Field Alternatives Review

Prepared for: Nevada Department of Transportation

May 3, 2012

USA Parkway
SR 439

EXHIBIT 4A
LOCATION #3: ROADWAY PLAN
"USA" 400+00 TO 450+00

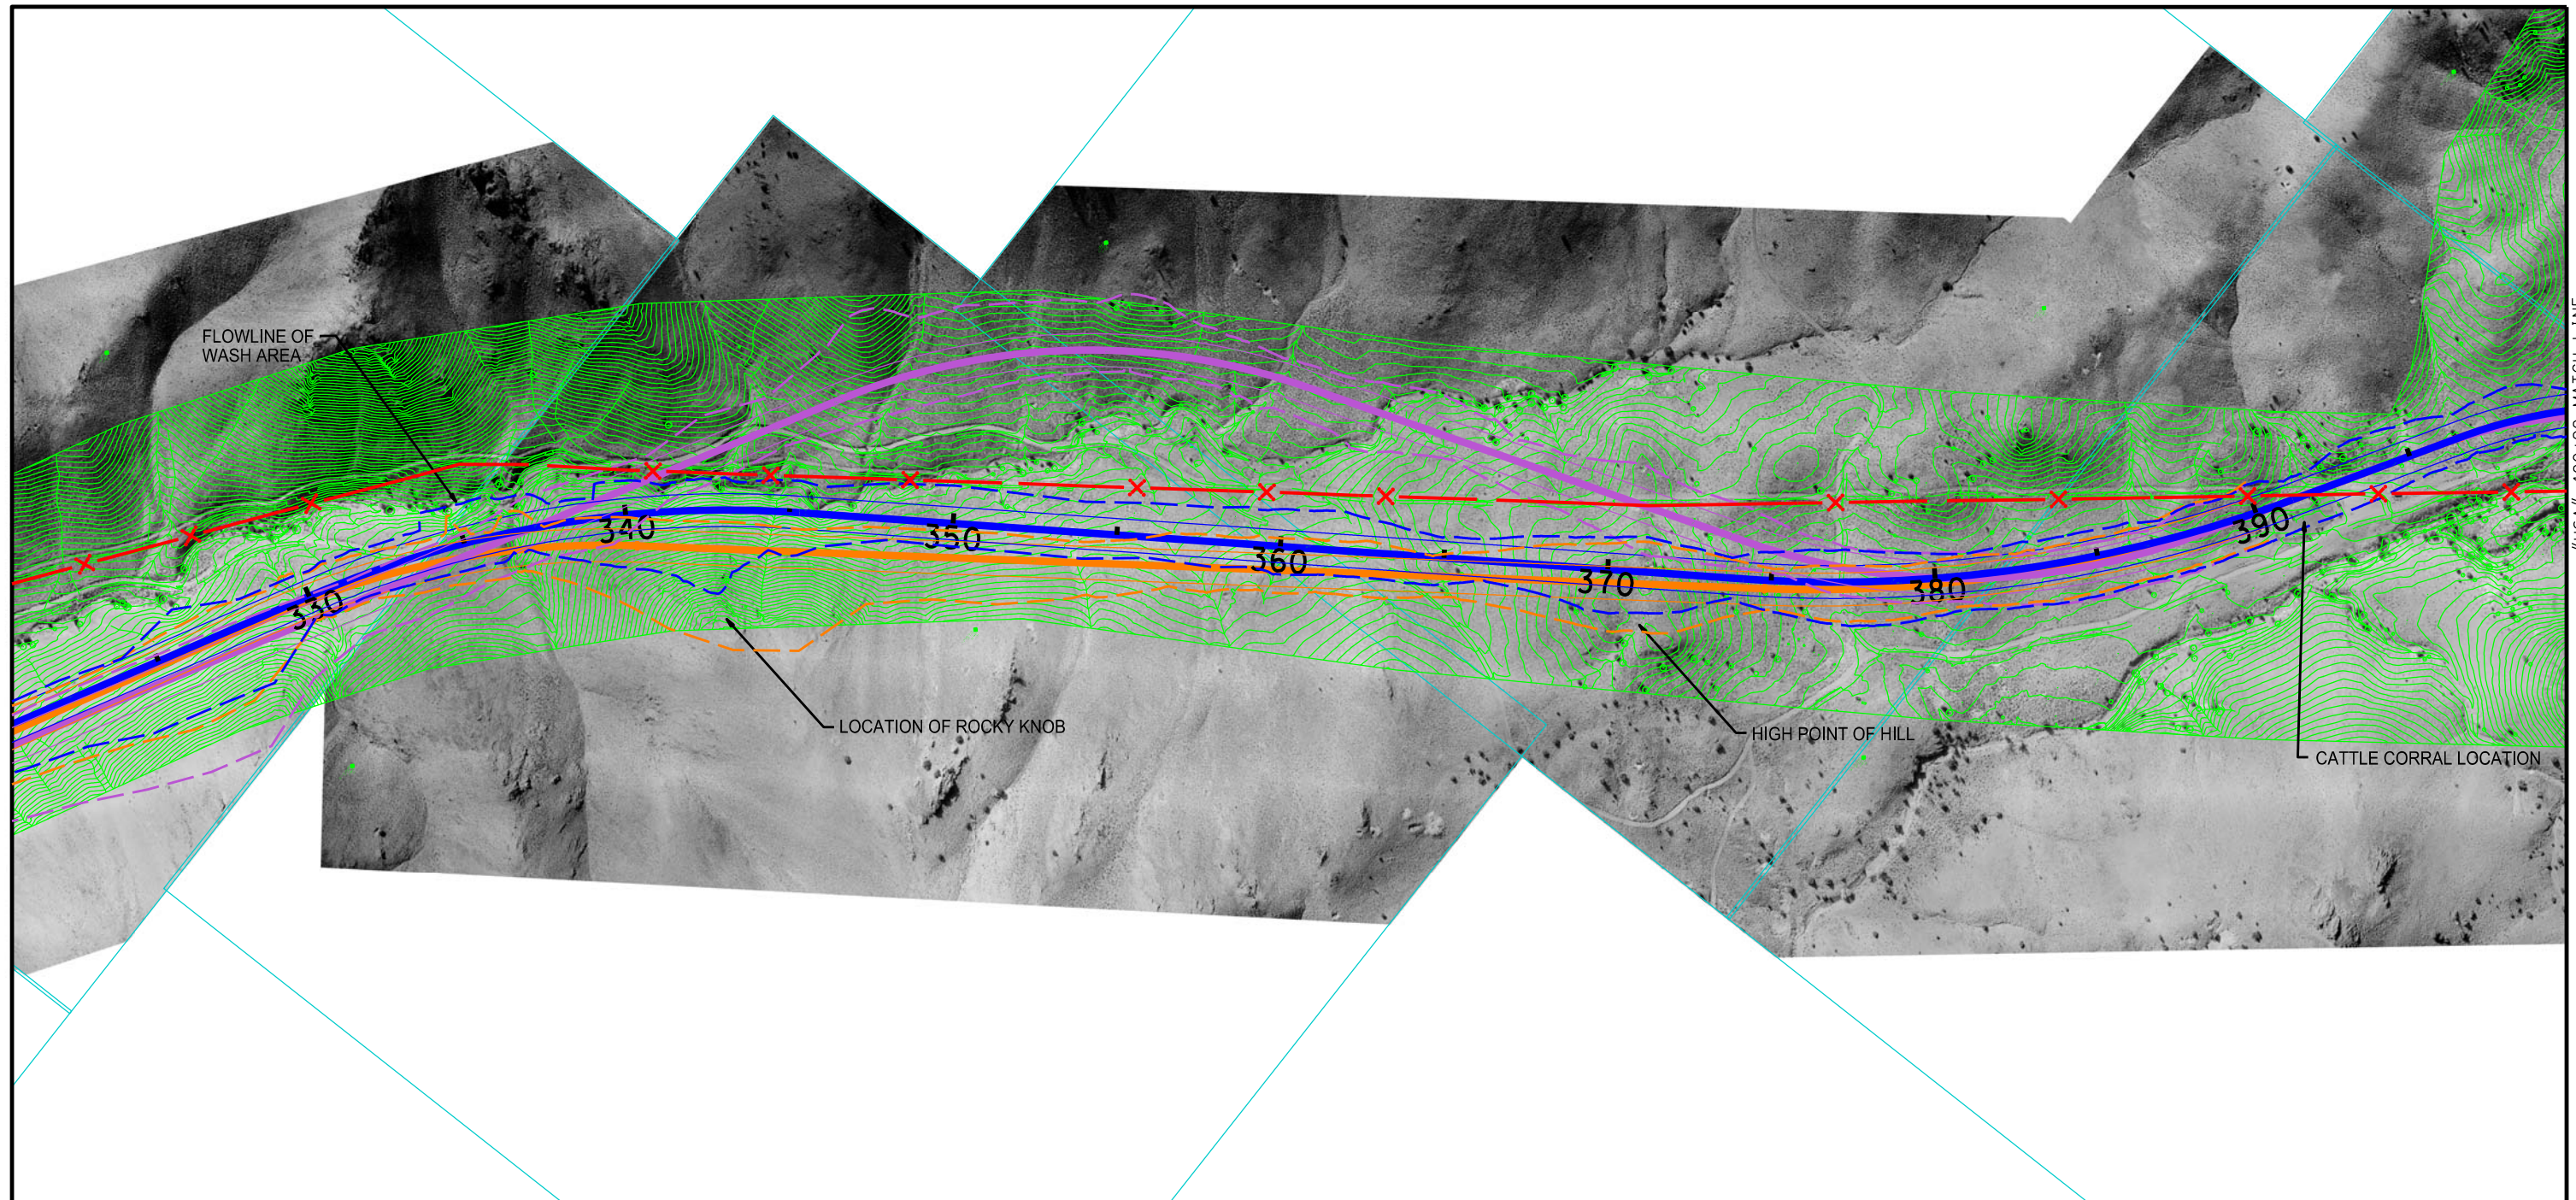
Alignment Refinements Station 400+00 to 450+00

Modified Field Review Alignment -1 is shown in orange line work on Exhibit 4A. As shown in photos #4 through #9, the alignment through this location traverses a series of hillside peaks and valleys. Comments received during the field visit recommended a straightening of the primary alignment to more closely follow the existing power lines through this location. This allows for simpler geometry with a reduction in the amount of horizontal curvature. This refinement will also lessen any potential impacts to the drainage wash that runs parallel to the primary alignment through this area. In order to accurately analyze the earthwork quantities associated with this refinement, additional development of the digital terrain model will be required. Based on the impacts of the earthwork analysis, this refinement will be considered in lieu of the original field review alignment shown in blue on Exhibit #4A.

EXHIBIT 4B
LOCATION #3: ROADWAY PLAN
"USA" 310+00 TO 390+00

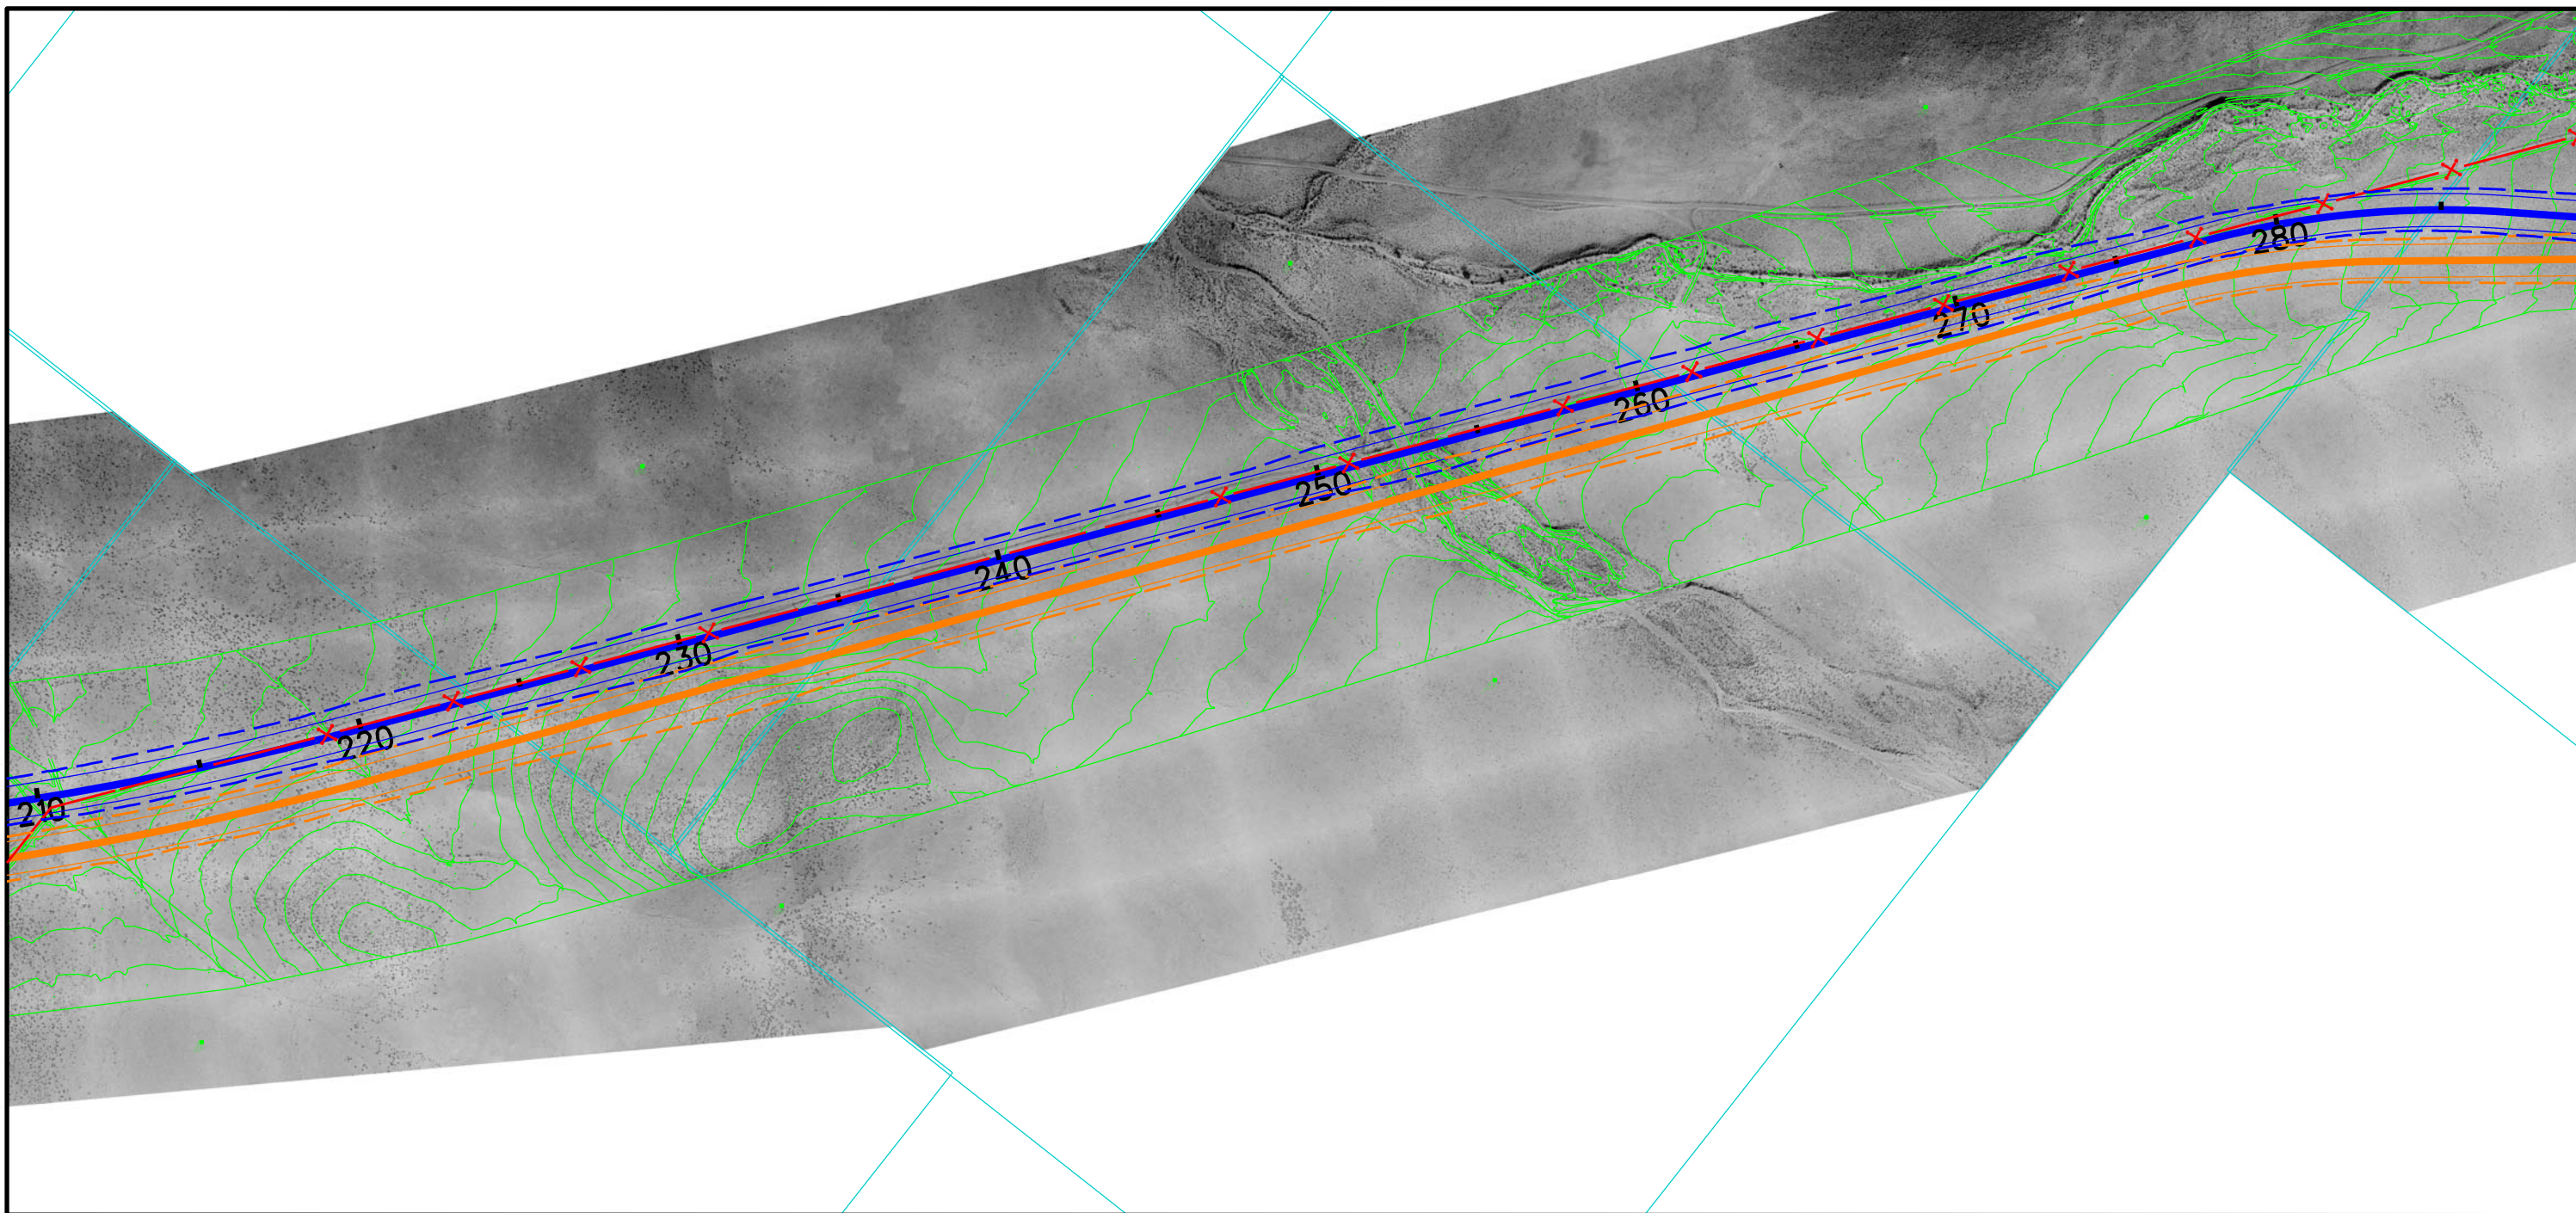
Alignment Refinements Station 310+00 to 390+00

Modified Field Review Alignment -1 (shown in orange line work) and Modified Field Review Alignment -2 (shown in magenta line work) are depicted along with the Original Field Review Alignment on Exhibit 4B. As shown in photos #11 through #18, the alignment heading north to south through this location traverses a hilltop and travels down a defined valley with a wash at the bottom.

Modified Field Review Alignment – 1 is being considered to lessen the impacts to the existing drainage wash at the bottom of the valley. The Original Field Alignment has issues with the toe of the embankment fill slope significantly impacting the existing wash. This proposed refinement pushes the alignment up the existing hillside to the east, away from the wash. Earthwork analysis, as well as consideration of retaining walls and realignment of the existing wash, will be considered in selection of the preferred alignment through this location.

Modified Field Review Alignment – 2 is being considered to reduce the large amount of cut required to construct the Original Field Review alignment through this location. Comments received during the field visit recommended a possible realignment on the west side of the existing wash to avoid the large excavation through an existing side slope the original alignment traverses. This refinement requires two additional crossings of the existing wash and initial review has

indicated that the reduction in excavation may not be significant. This refinement would also introduce additional curvature and geometric complexity. A similar analysis considering earthwork quantities, the use of retaining walls, as well as potential realignment of the existing wash will be considered in selection of the preferred alignment in this location.
